**Report: TAB REPORT**  
**Function: Test, Adjust, & Balance**  
**Date: 06/26/2024**

## 06-24-24 WALGREENS #1769 - DENVER, CO

## Project Summary

EF2\_DROP  
07/25/2023

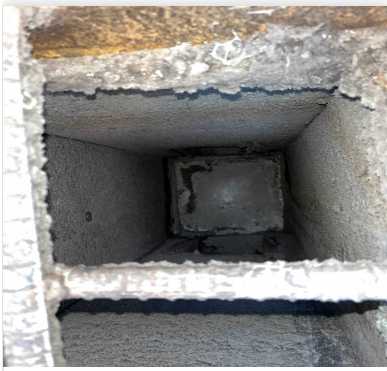
**Issue Name :** EF2 No Backdraft Damper  
**Description :** No backdraft damper was found in the EF2 ductwork. Recommend installing to prevent drafting into the restrooms when the fan is not running.  
**Created By :** National TAB                      **Assigned To :** National TAB - Stephen Tassinaro  
**Status :** Open  
**Priority :** Medium                                      **Asset Tag :**  
**Originated Date :** 07/25/2023 - Stephen Tassinaro - National TAB

- **06/17/2024 National TAB - Stephen Tassinaro**
  - No damper installed.

**Dirty\_Filters**  
**06/19/2024**

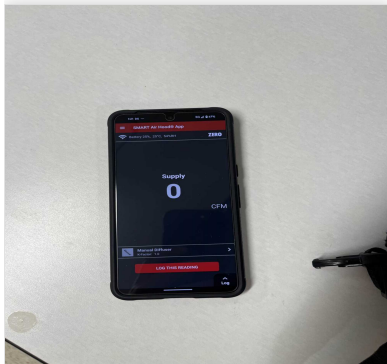
**Issue Name :** RTU Final Filters  
**Description :** Recommended to install the appropriate sized MERV 8 or better throwaway filters in the RTUs for improved filtration.  
**Created By :** National TAB                      **Assigned To :** National TAB - Stephen Tassinaro  
**Status :** Open  
**Priority :** Medium                                      **Asset Tag :**  
**Originated Date :** 07/20/2023 - Stephen Tassinaro - National TAB

- **06/17/2024 National TAB - Stephen Tassinaro**
  - MERV 8 filters now installed in all units, but they are dirty and due for replacement.

Asset: EF3

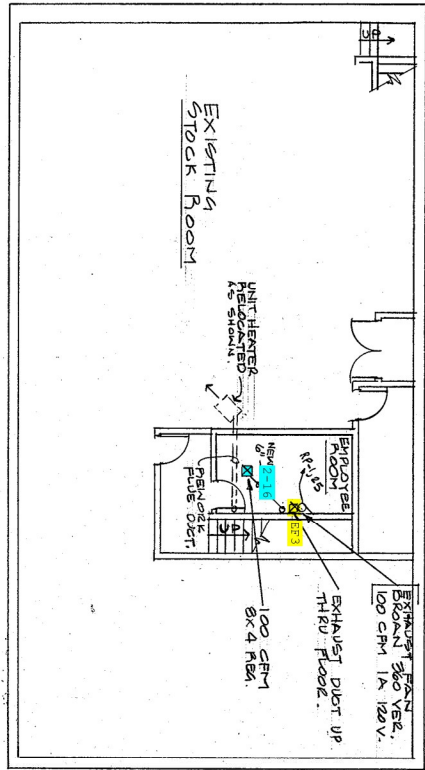
Notes:  
FAN RUNNING BUT DIRTY AND IN NEED OF CLEANING.
